ATZC-DOE (200-D)

SUBJECT: Approval with Modifications for Voluntary Corrective Action Report for FTBL-11/SWMU-29, U.S. Army Air Defense Artillery Center and Fort Bliss.

FTBL-11
 LOCATION AND SURFACE WATER FLOW

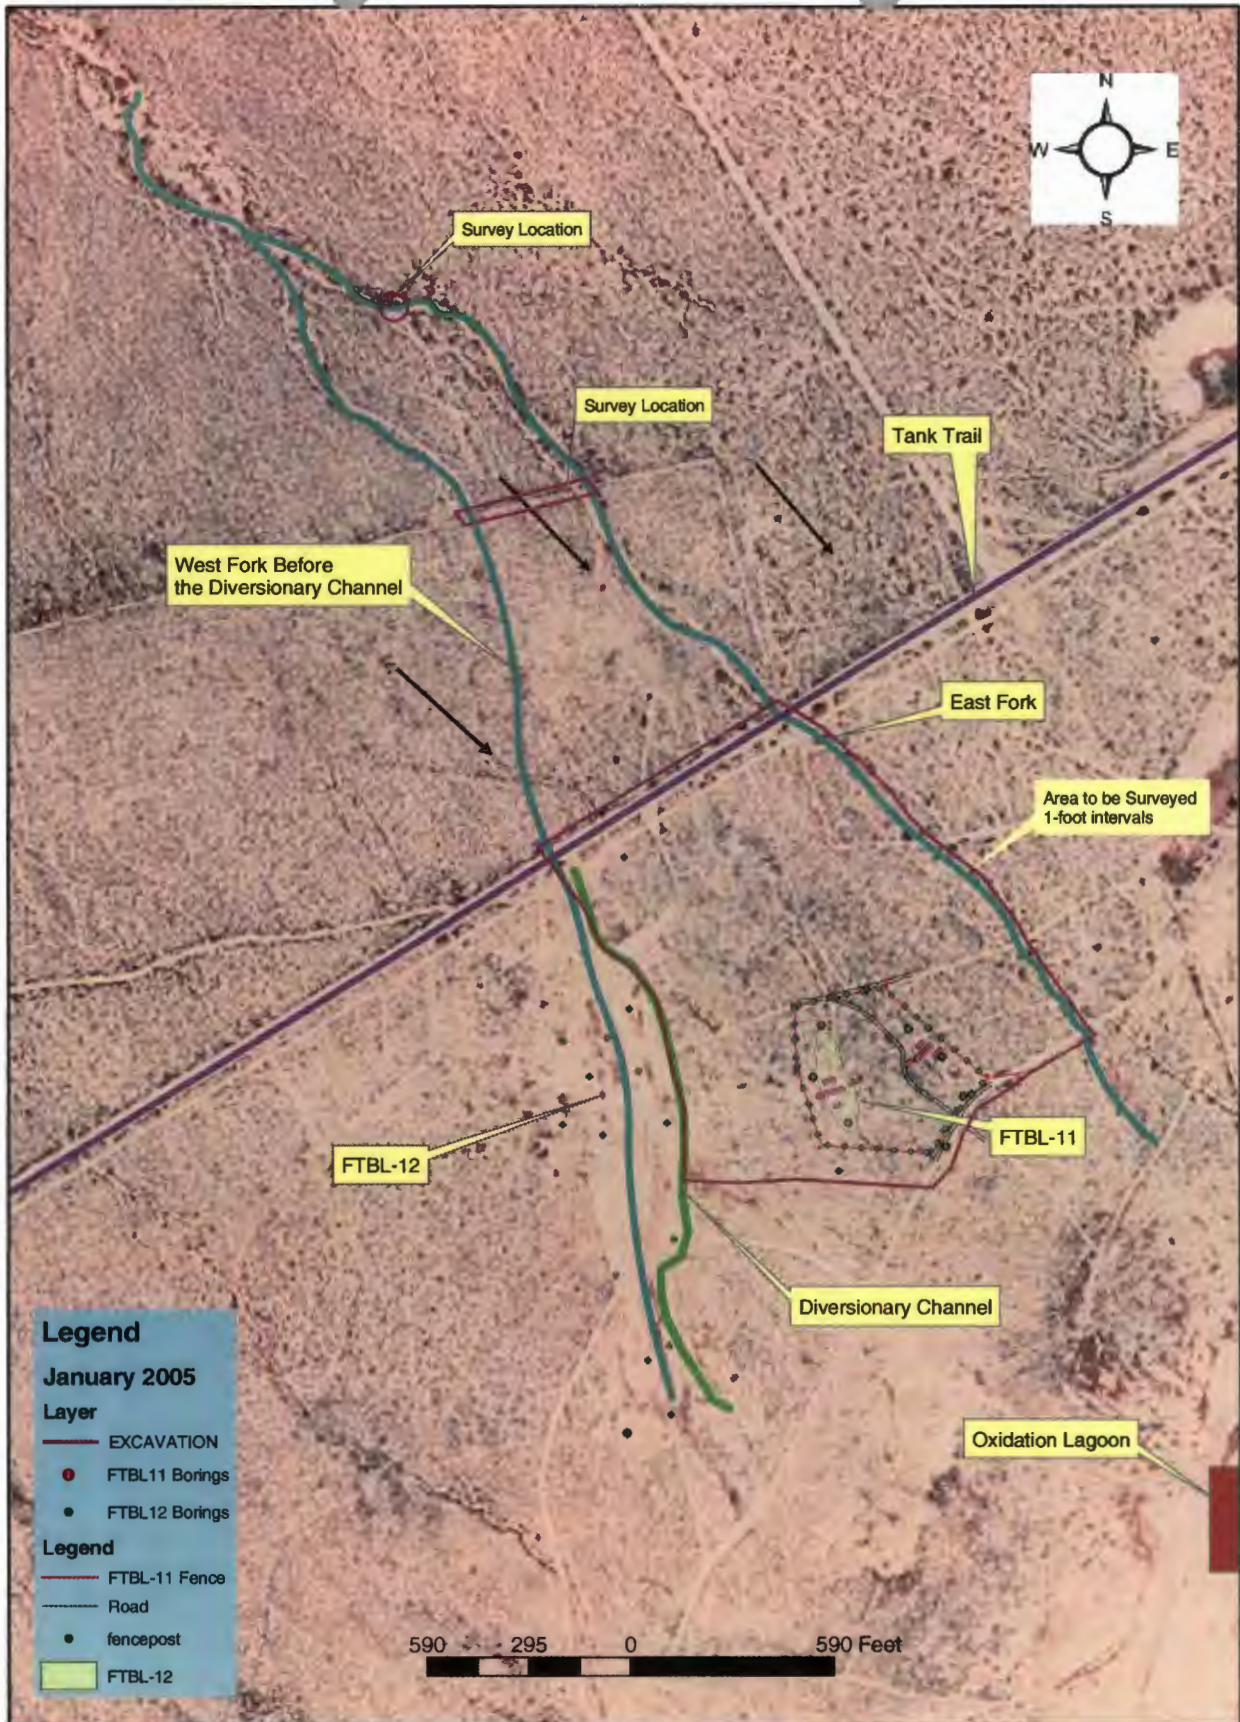
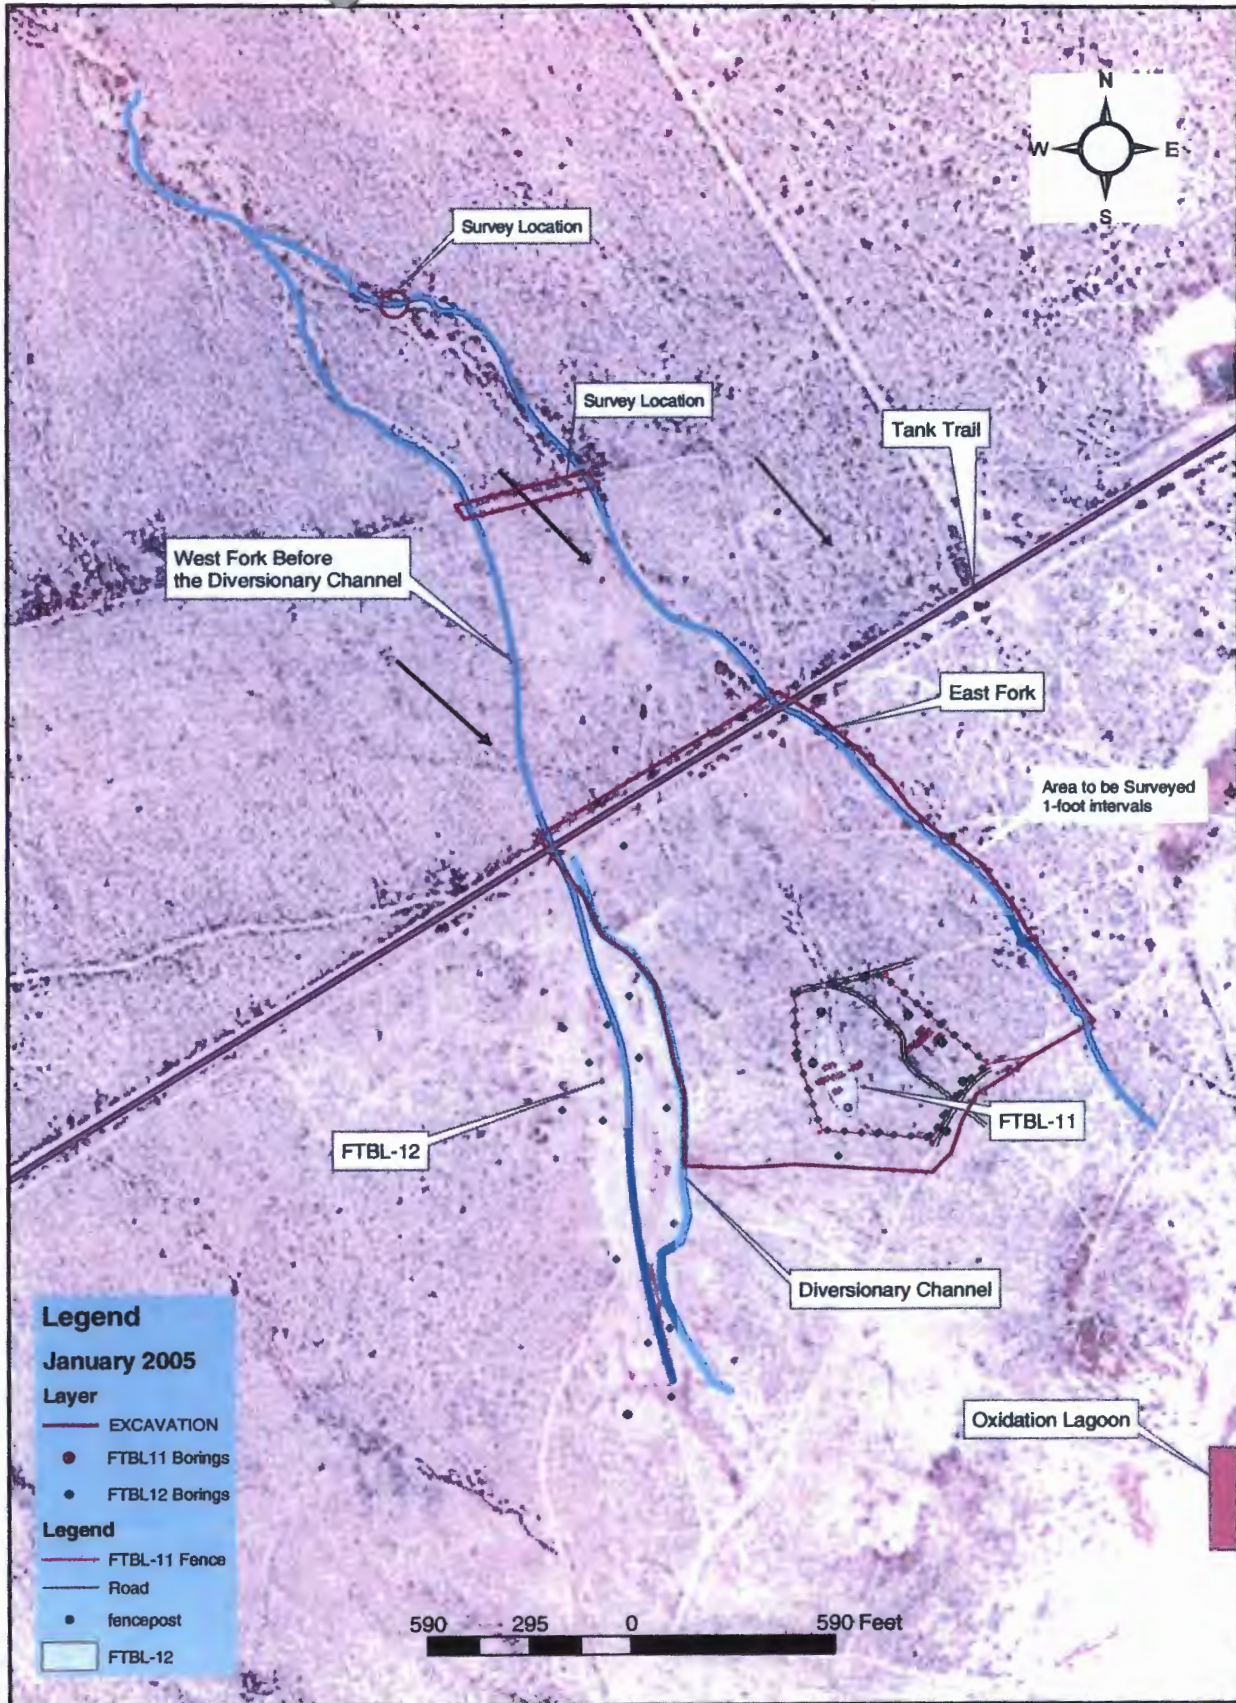
NMED does not concur with Fort Bliss recommendation to close FTBL-11/SWMU-29/SWMU-29 "as is". Fort Bliss shall install and maintain run-on controls at the site to prevent the occurrence of standing water and diminish future risk of transport of contaminants from the waste buried at the landfill. Fort Bliss must submit documentation to NMED after the completion of installation of run-off controls at SWMU-29.

The results from the watershed analysis indicated that the surface water flow in the general area of FTBL-11/SWMU-29 is from a northeasterly direction. An analysis of Enclosure 1 indicates the following:

- a. The majority of the runoff from the upslope area is diverted away from FTBL-11/SWMU-29 into two forks of an established stream system. The east fork runs approximately 260 feet to the east of the eastern fence line of FTBL-11/SWMU-29. The west fork was redirected away from FTBL-12/SWMU-27 by the diversion channel that was constructed during the period the FTBL-12/SWMU-27 cover was placed.

- b. The watershed is dissected east-to-west by the Tank Trail, which is located approximately 800 feet north of FTBL-11/SWMU-29. The Tank Trail has a bermed drainage ditch that parallels its south side. Most of the water entering from the north, both through arroyos or sheet flow, is captured by bar ditches and channeled to the east fork or the west fork diversion channel. However, some storm water passes through a breach in the Tank Trail berm toward FTBL-11/SWMU-29. The breach is located approximately in the middle of the proposed earth work immediately south of the Tank Trail.

- c. A small arroyo (less than two feet deep and three feet wide) forms approximately 300 feet north of FTBL-11/SWMU-27 and runs along the western edge of the landfill.

- a. Survey the area bounded by the two larger-scale arroyos east and west of FTBL-11/SWMU-27 and bounded by the Tank Trail to the north and a secondary road south of FTBL-11/SWMU-27. The survey data will be generated from spot elevations spaced 50-feet on center and will be used to develop a contour map with 1-foot intervals.

- b. Construct a berm at the breach in the Tank Trail north of FTBL-11/SWMU-27 and deepen the drainage ditch to route run-off to either the east or west forks. The earthwork will be reinforced or armored, if needed.

- c. Construct a new diversion channel between the Tank Trail and FTBL-11/SWMU-27 to capture run-off and route it to the west and into the diversion channel east of FTBL-12/SWMU-29. The earthwork will be reinforced or armored, if needed.

- d. Install ciber stakes and signage along the Tank Trail earthwork to prevent future interference with the drainage system or berm.
